7ABC BAYHAM STREET CAMDEN LIFESTYLE

SECTION 73 PROPOSED SCHEME AMENDMENTS
PLANNING APPLICATION
NOVEMBER 2020

This document has been prepared to present the amendments to the consented scheme (Ref: 2018/3647/P) which are predominantly internal and designed to suit the hotel brand.

SECTION C-C

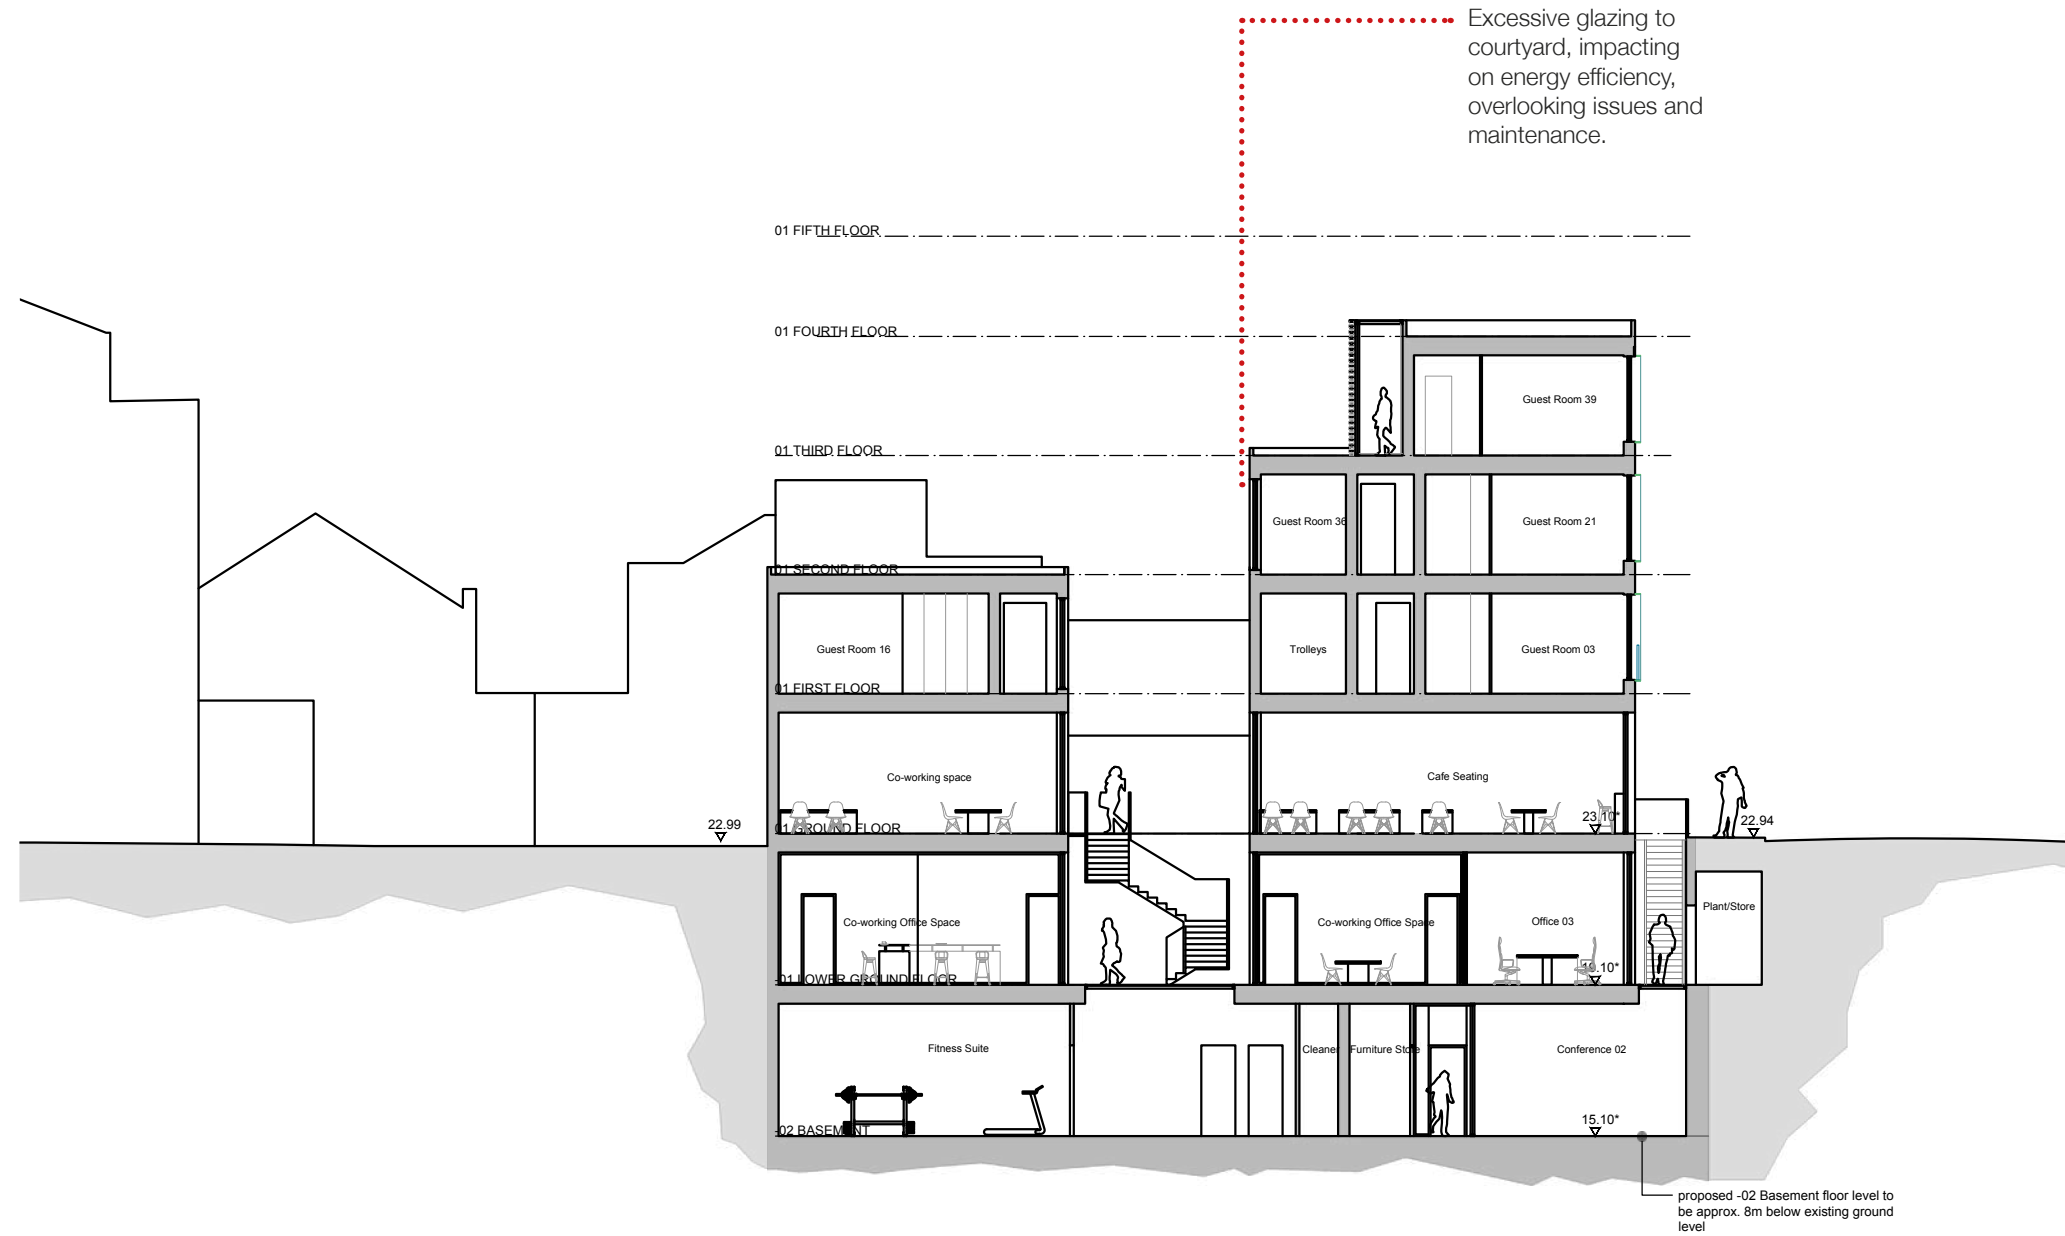
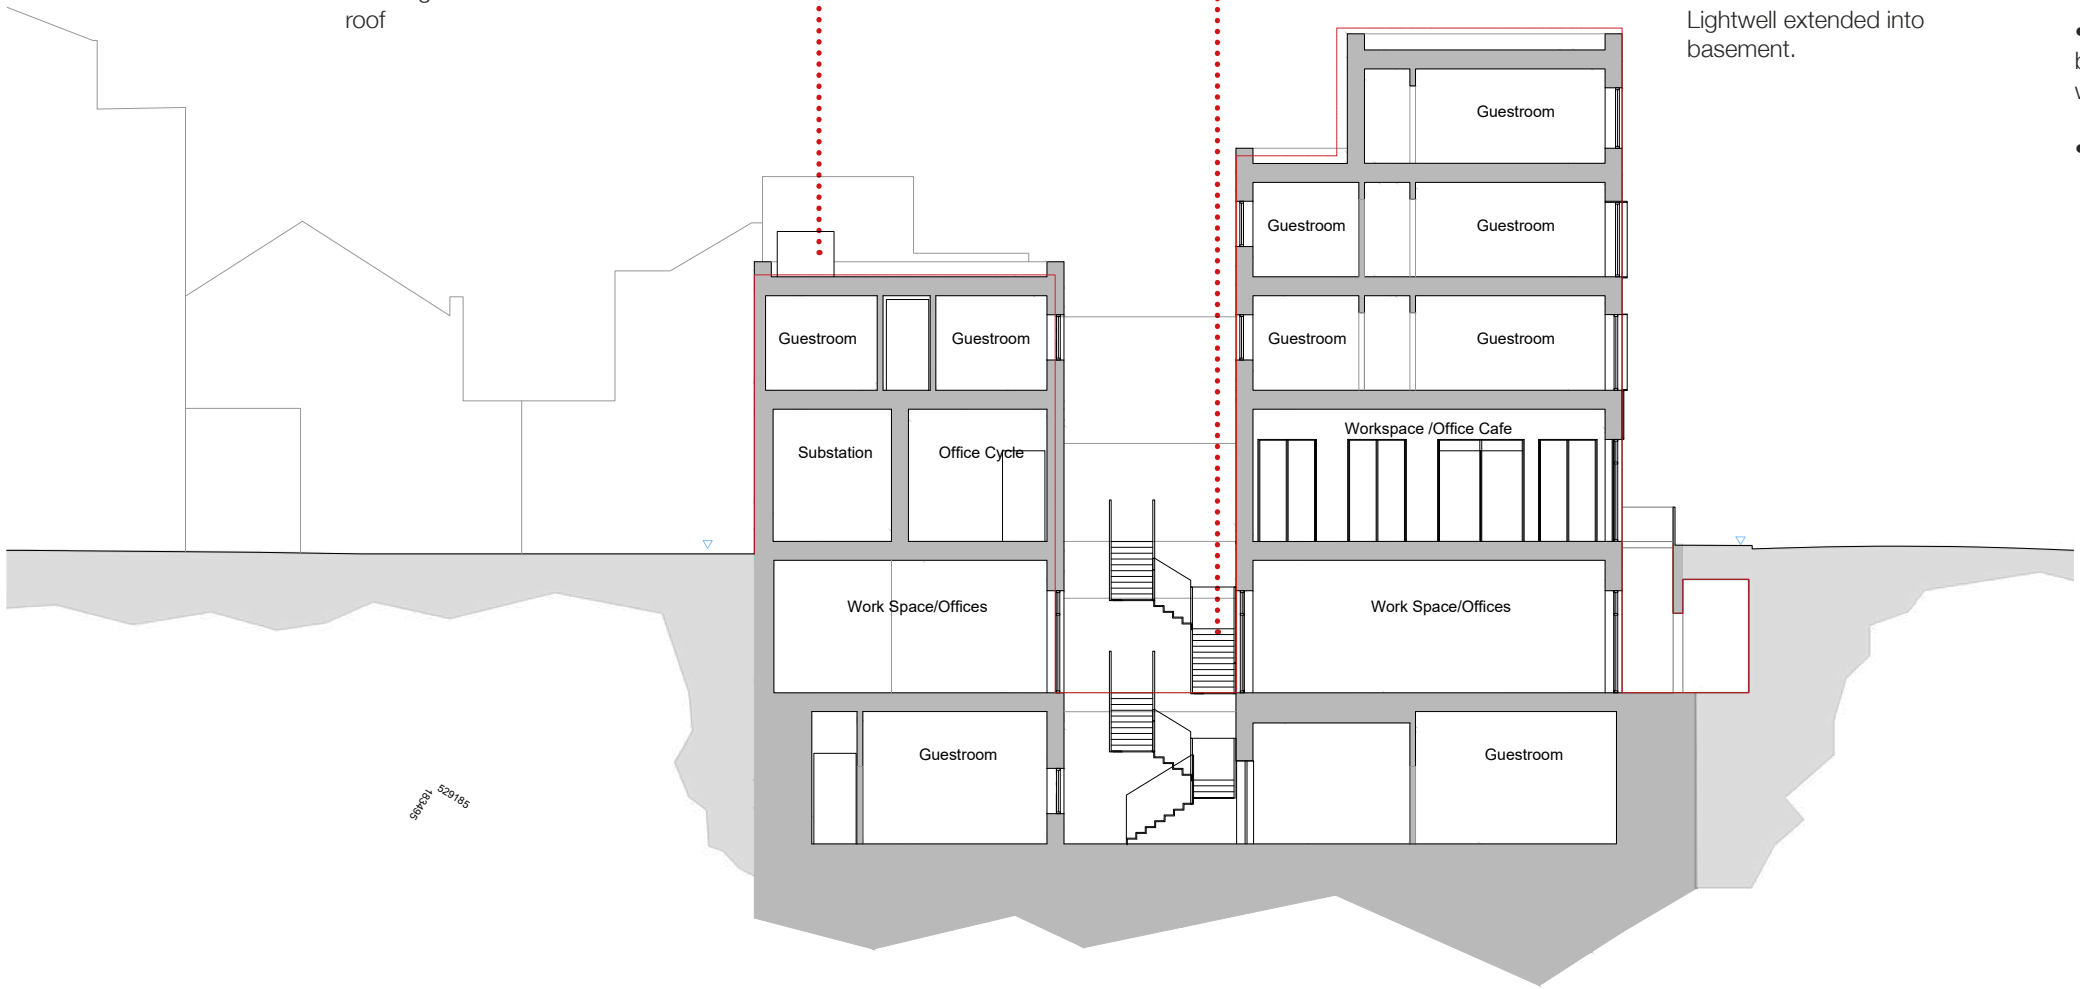
- General massing retained.
- Light well extended to Basement Level allowing light into basment guestrooms.
- Essential life safety generator located internally to minimise neigh-
bour impact and rooftop massing. Air in/out within roof and external
wall.
- Green Walls omitted in response to fire safety.

Essential life safety generator
located internally to minimise
nieghbour impact and rooftop
massing. Air vent located on
roof

Courtyard Fenestration
simplified allowing for less
overlooking and more
efficient maintenance.
Lightwell extended into
basement.

SECTION D-D

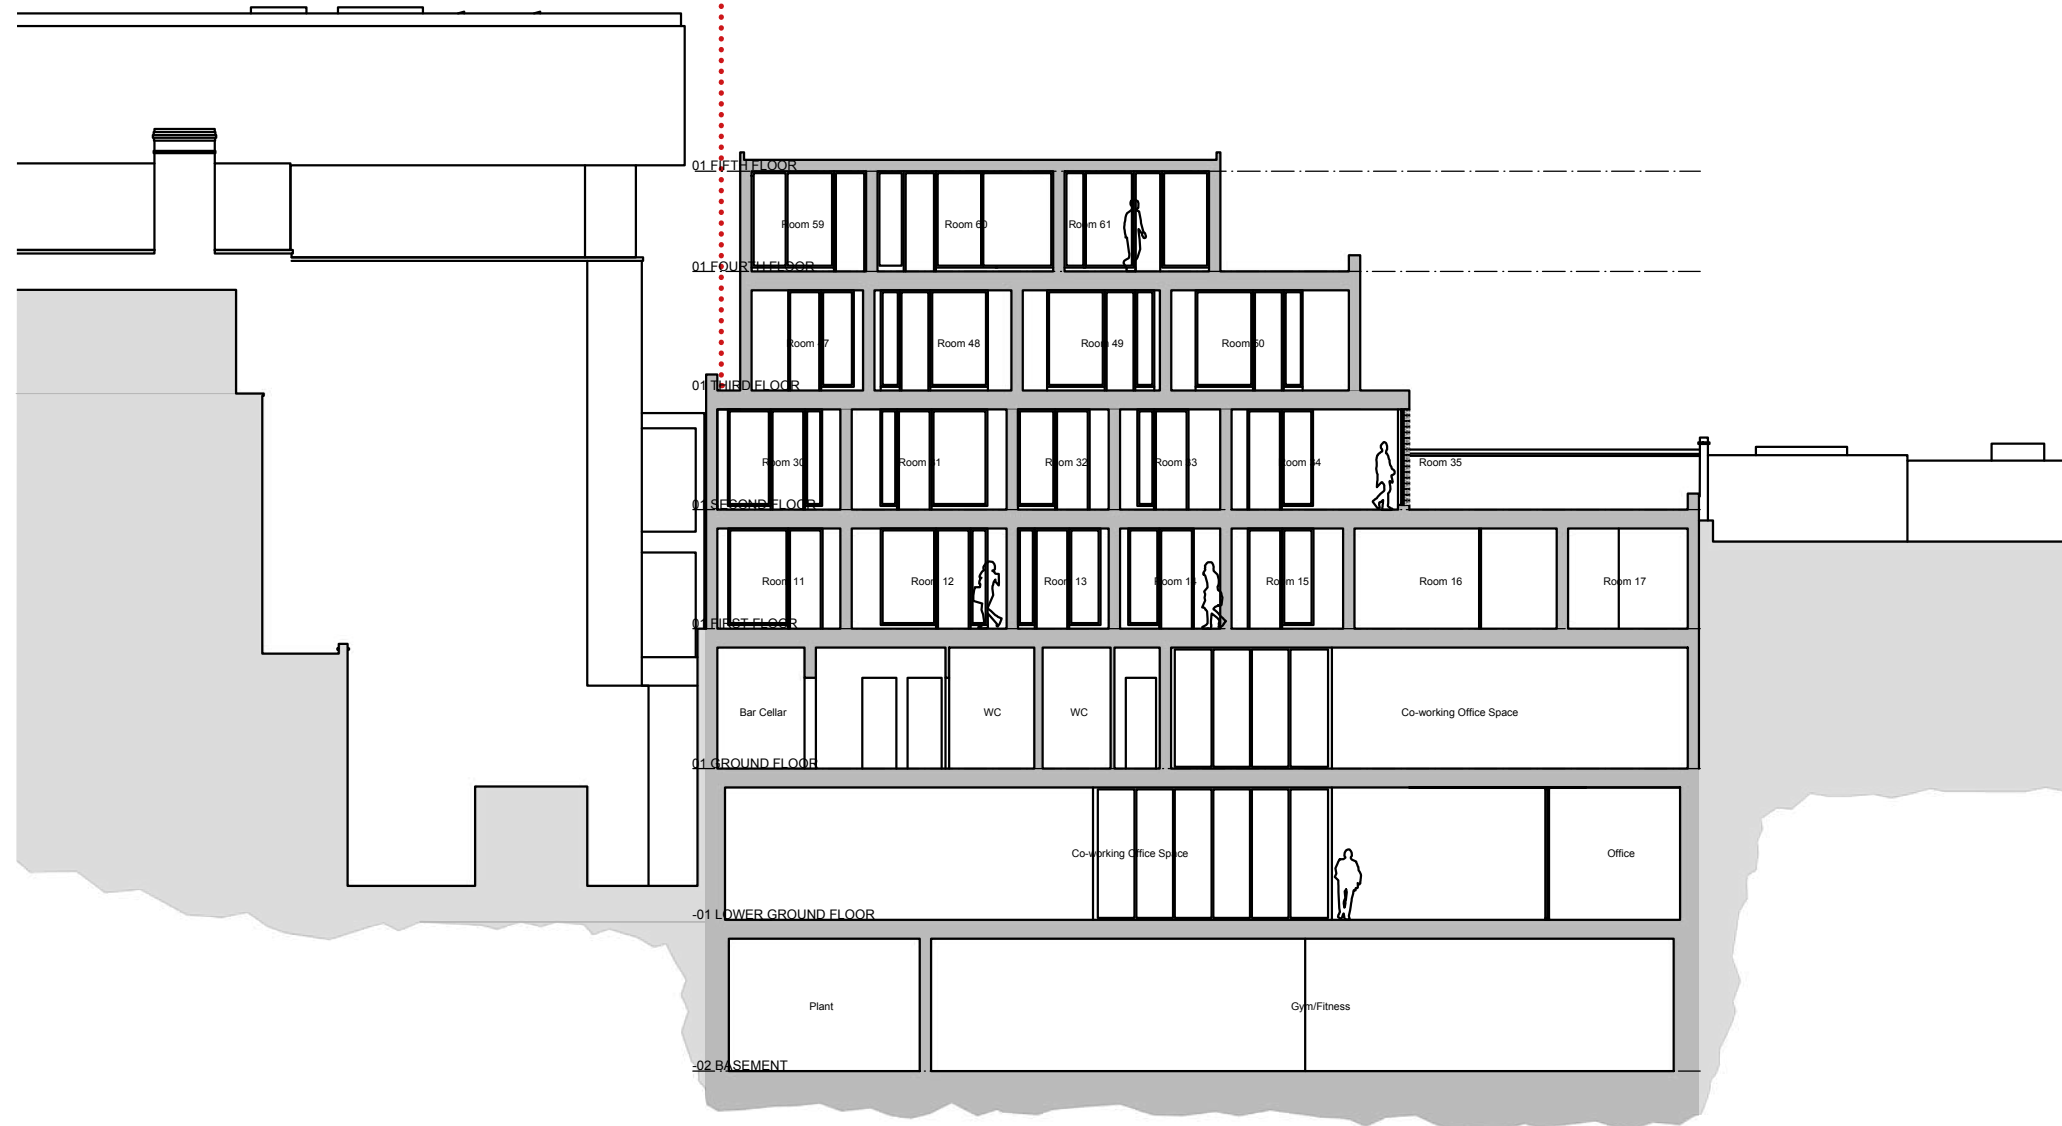
Excessive glazing into
neighbouring courtyard,
impacting on overlooking
issues and maintenance.

South facade simplified by reducing glazing extent to minimise overlooking and enhance neighbouring courtyard.

Simplified building volume.

Essential life safety generator located to minimise neighbour impact and rooftop massing. Safe maintenance access provided by means of proposed second stair.

- General massing retained except massing realigned at lower levels to simplify construction.
- Essential life safety generator located internally to minimise neighbour impact and rooftop massing. Air in/out within roof and external wall.
